China Opinion of Initial Burst Pressure Reduction to 200%NWP for Carbon Fiber

Opinion: Agree for 70MPa only

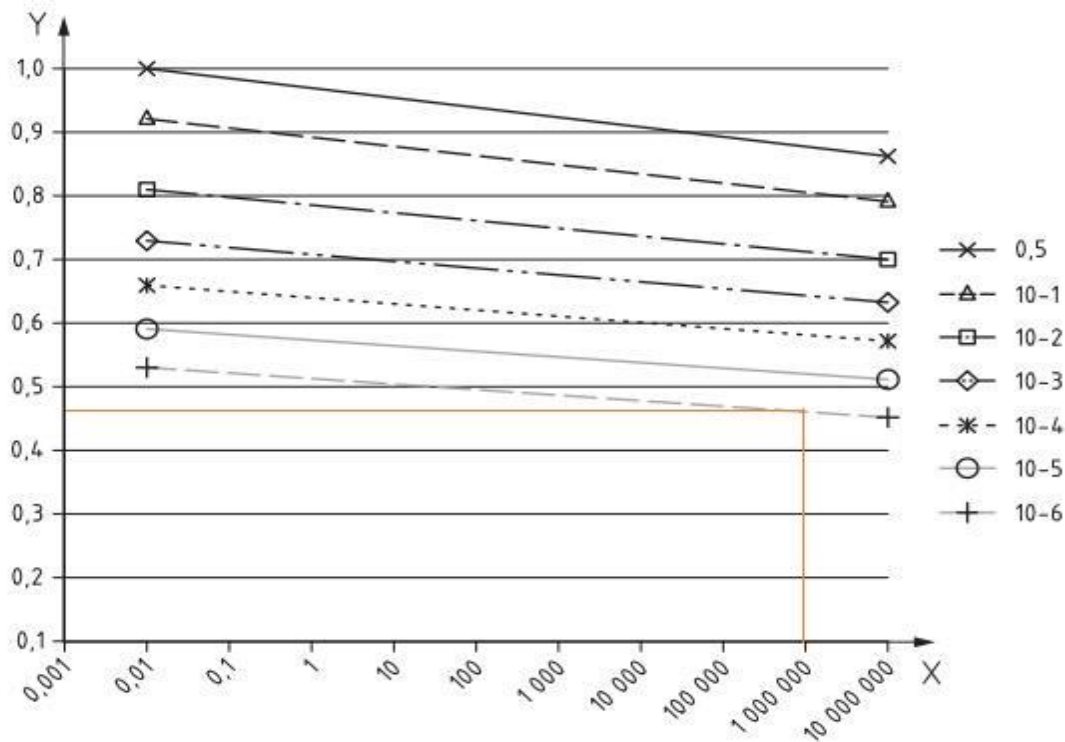
3、 According to ISO13086 《Gas cylinders — Guidance for design of composite cylinders 》 . Stress ratio 2.25 is intended to provide a reliability of 0,999999 over the cylinder lifetime; that is, less than 1 failure in 1,000,000 cylinder lifetimes. More material data are required to prove the reliability can be reached after reduction of stress ratio to 2.0.
